HADDAM NECK PLANT

AMENDMENT TO FACILITY OPERATING LICENSE

Amendment No. 175
License No. DPR-61

ATTACHMENT TO LICENSE AMENDMENT NO. 175

FIGURE 3.9-1 SPENT FUEL POOL RACK MINIMUM BURNUP REQUIREMENTS FOR ALTERNATING ROWS STORAGE CONFIGURATION

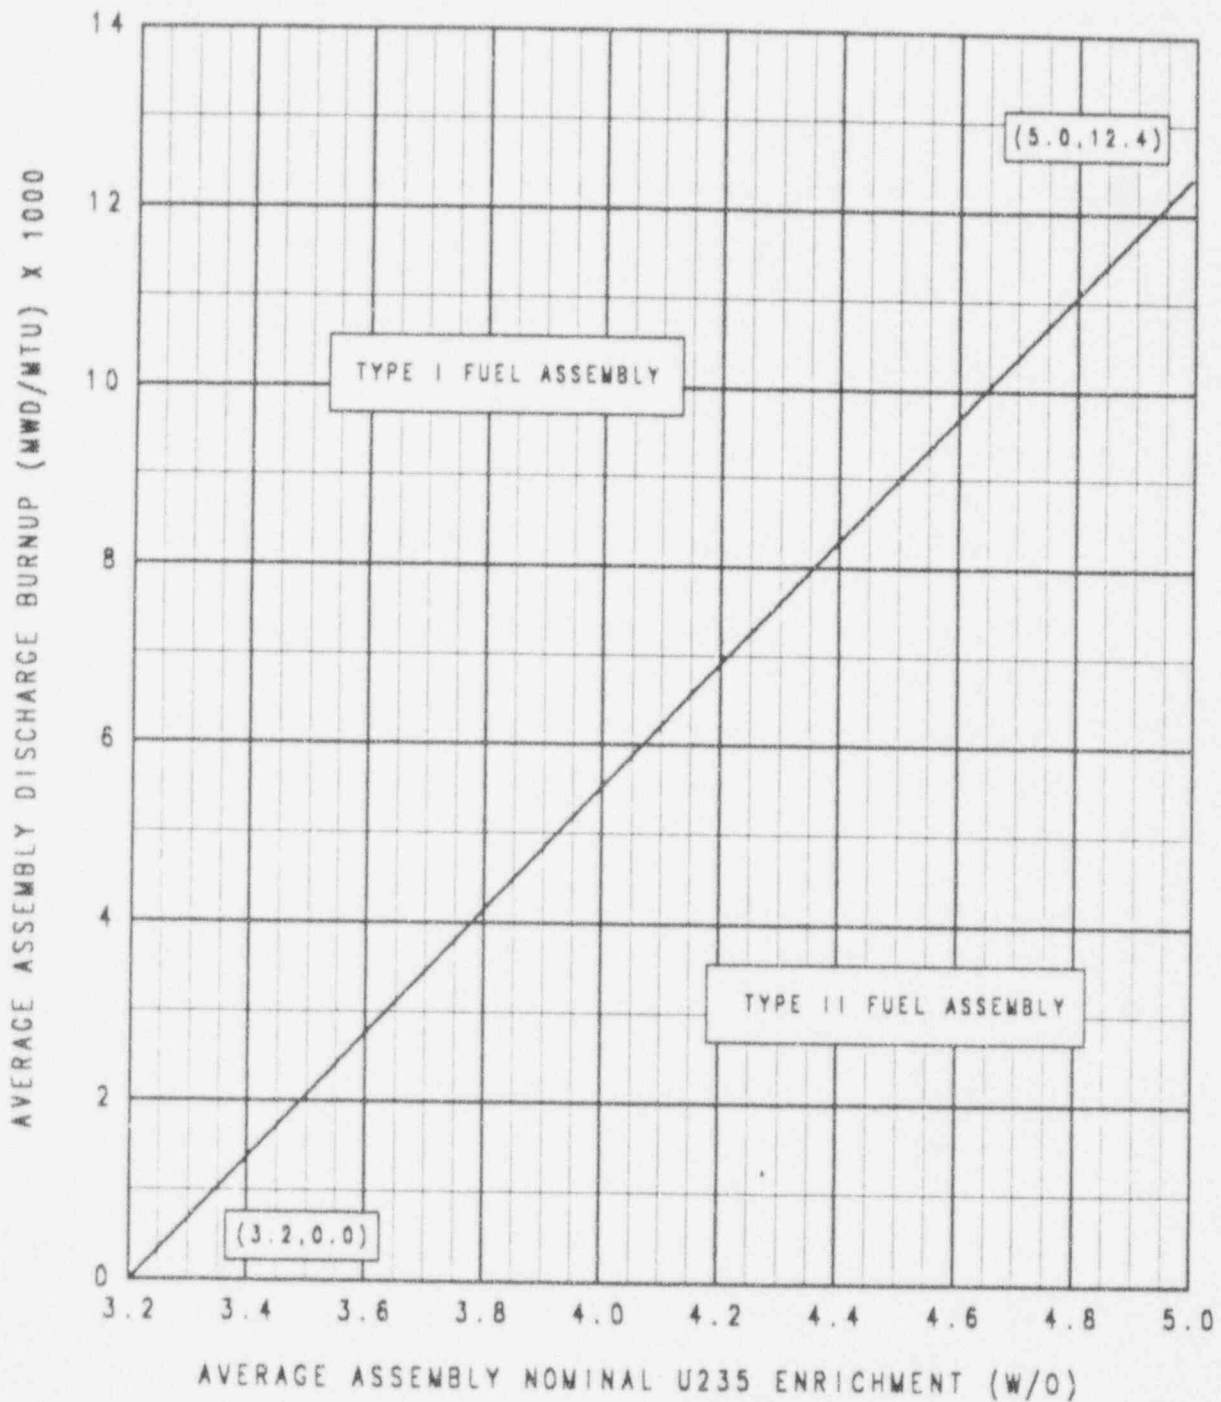
- 1.38 TYPE I FUEL ASSEMBLY is a fuel assembly with an initial average assembly nominal enrichment less than or equal to 3.2 weight percent U-235 or an average assembly burnup/average assembly nominal enrichment as shown in Figure 3.9-1. This definition applies to all fuel types (e.g., stainless steel or zircaloy cladding, stainless steel or zircaloy skeleton).
- 1.39 TYPE II FUEL ASSEMBLY is a fuel assembly with an initial average assembly nominal enrichment greater than 3.2 weight percent U-235 and an average assembly burnup/average assembly nominal enrichment as shown in Figure 3.9-1. This definition applies to all fuel types (e.g., stainless steel or zircaloy cladding, stainless steel or zircaloy skeleton).

Immediately initiate actions to correct the loading error if the placement of fuel assemblies does not meet the requirements of both Figure 3.9-1 and Figure 3.9-2.

4.9.14 Ensure that all fuel assemblies to be placed in the spent fuel pool are within the enrichment and burn-up limits of Figure 3.9-1 by checking the assembly's design and burn-up documentation. TYPE I FUEL ASSEMBLIES and TYPE II FUEL ASSEMBLIES will be stored as shown in Figure 3.9-2

FIGURE 3.9-2 SPENT FUEL POOL RACK ALTERNATING ROW STORAGE CONFIGURATION

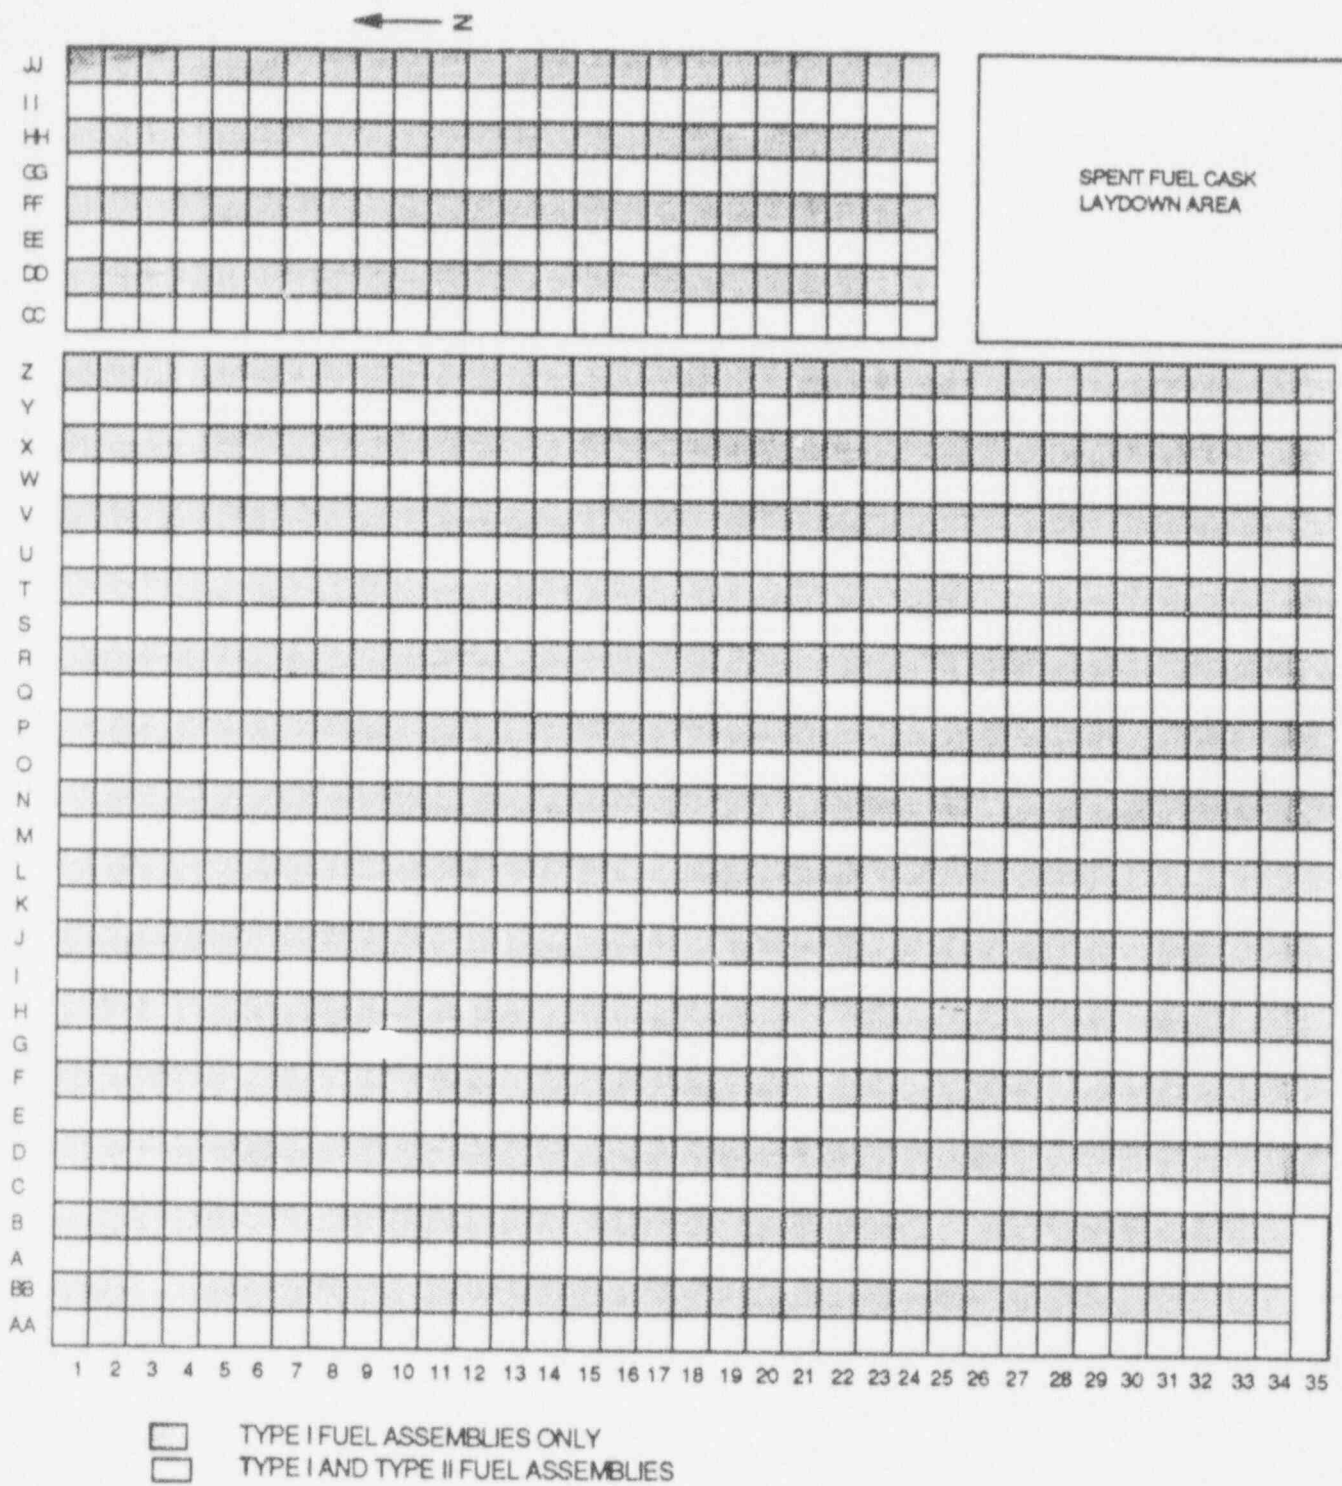
- a. A nominal 10.75 inch center-to-center distance including neutron absorber surrounding each assembly to ensure a K_{eff} less than or equal to 0.95 when flooded with unborated water, and
- b. Fuel assemblies will be stored in an alternating row configuration. TYPE I and TYPE II FUEL ASSEMBLIES will be stored in accordance with the requirements of Specification 3.9.14.

FIGURE 5.6-1 NEW FUEL STORAGE RACK MINIMUM IFBA REQUIREMENTS

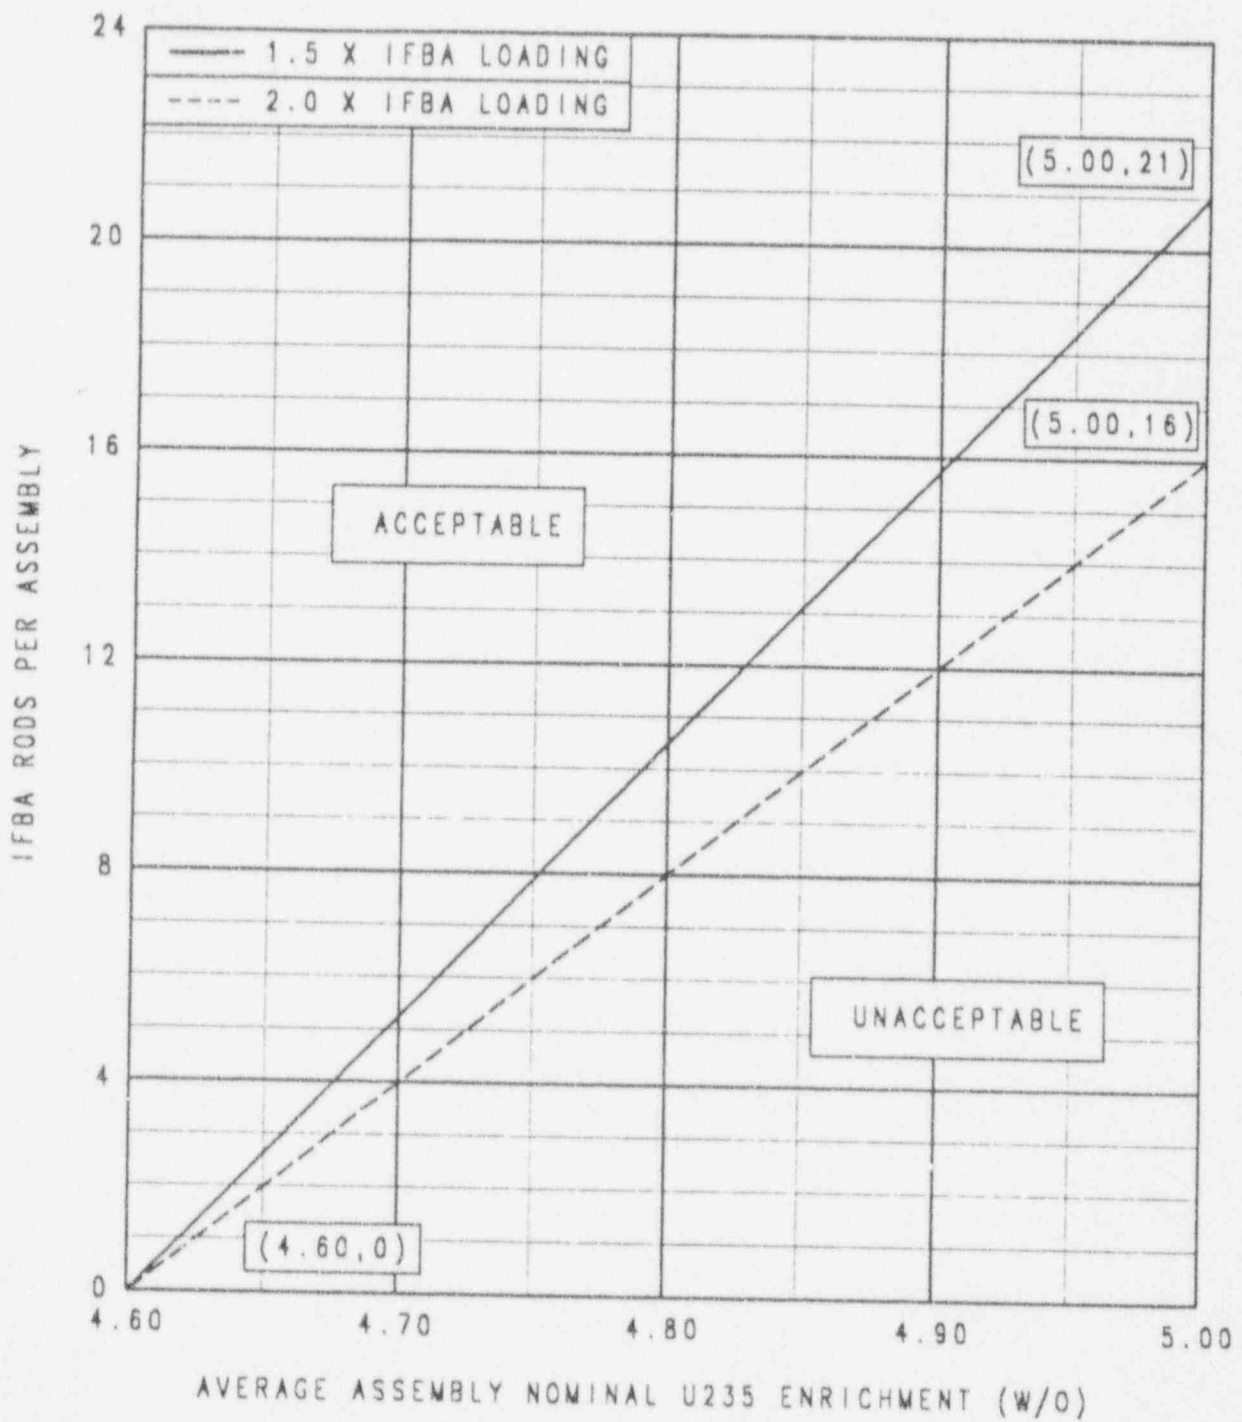
- a. A nominal 18.625-inch center-to-center distance with a full-length polyvinyl chloride liner to ensure a K_{eff} less than or equal to 0.95 when flooded with unborated water and less than or equal to 0.98 assuming optimum moderating conditions, and
- b. The maximum fuel assembly enrichment in the new fuel storage racks will be 5.0 weight percent U-235 (nominal). New fuel assemblies with an average enrichment greater than 4.60 weight percent U-235 (nominal) must contain Integral Fuel Burnable Absorbers (IFBA) rods in accordance with the requirements of Figure 5.6-1. New fuel assemblies will be stored in accordance with the requirements of Figure 5.6-2.
